Flowers-To-Brandywine Alternate Routings (Mercer Trail Study)

This document has supporting information for the alternative Flowers-to-Brandywine sidepath routing that would completely avoid the Henderson Mill Creek floodplain (Hollinswood-to-North Fork, remaining HMC segment per Oct 2 presentation).

Oct2 Presentation showing HMC Portions Removed and HMC Portion Remaining

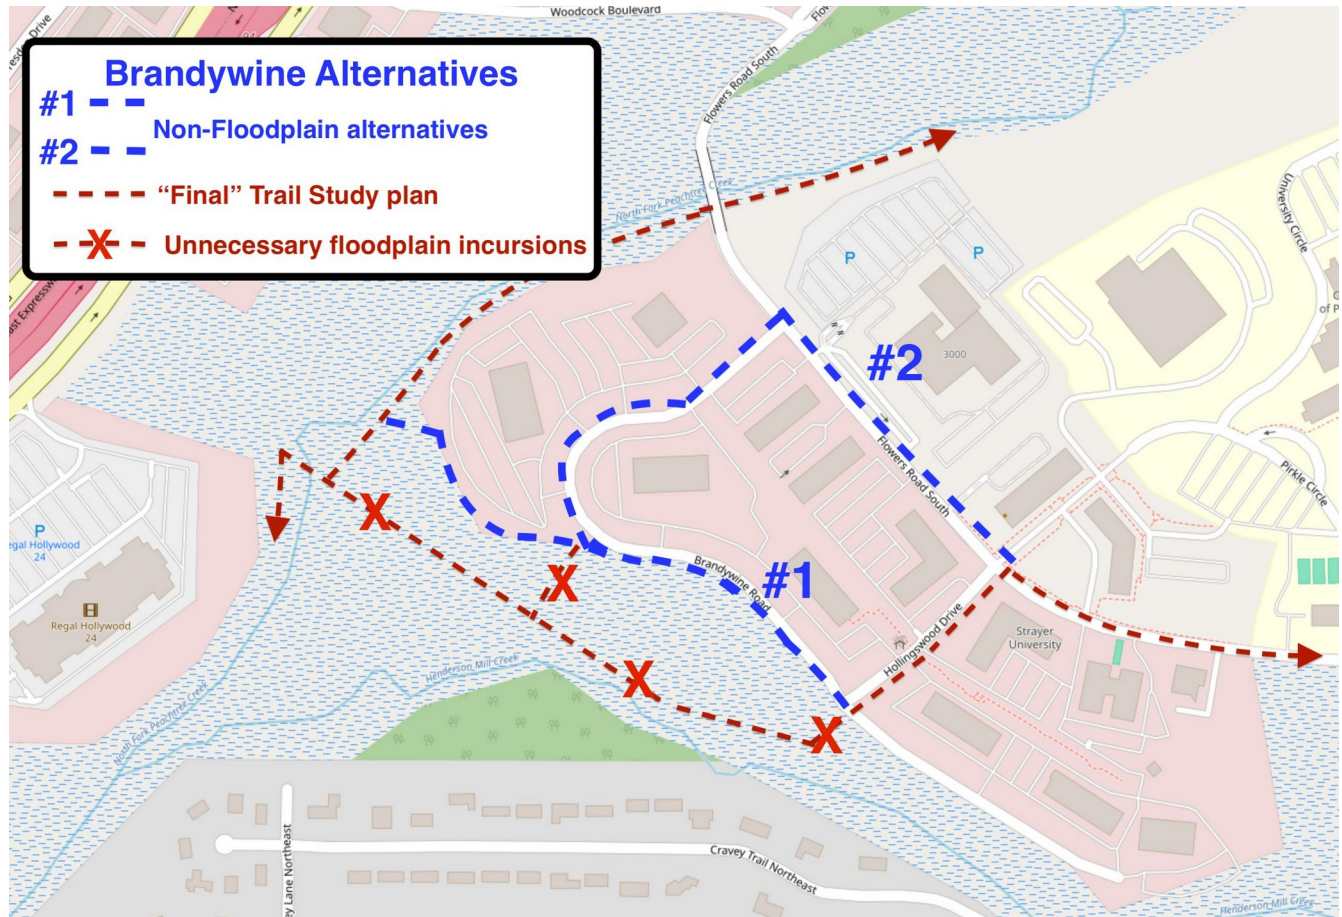
This remaining HMC floodplain segment (Hollinswood-to-North Fork) is not required in order to provide the desired Mercer connectivity. The alternate Flowers-to-Brandywine routings can provide this connectivity without touching any of the HMC floodplain.

Direct North Fork Access in Close Proximity to Parking Lot Sidepath

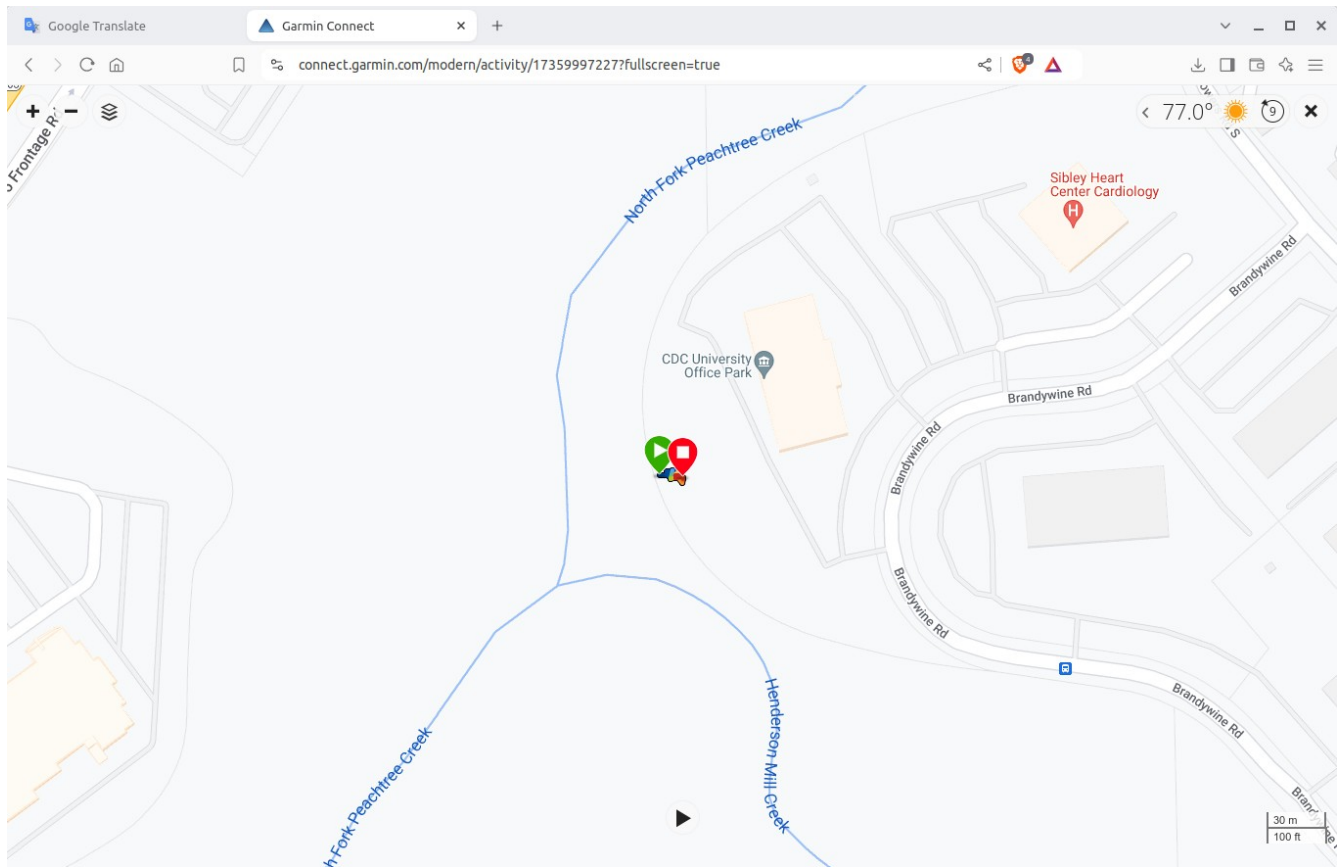
This GPS position is parallel to the edge of the building, and is within the area where the land is level behind the vegetation.
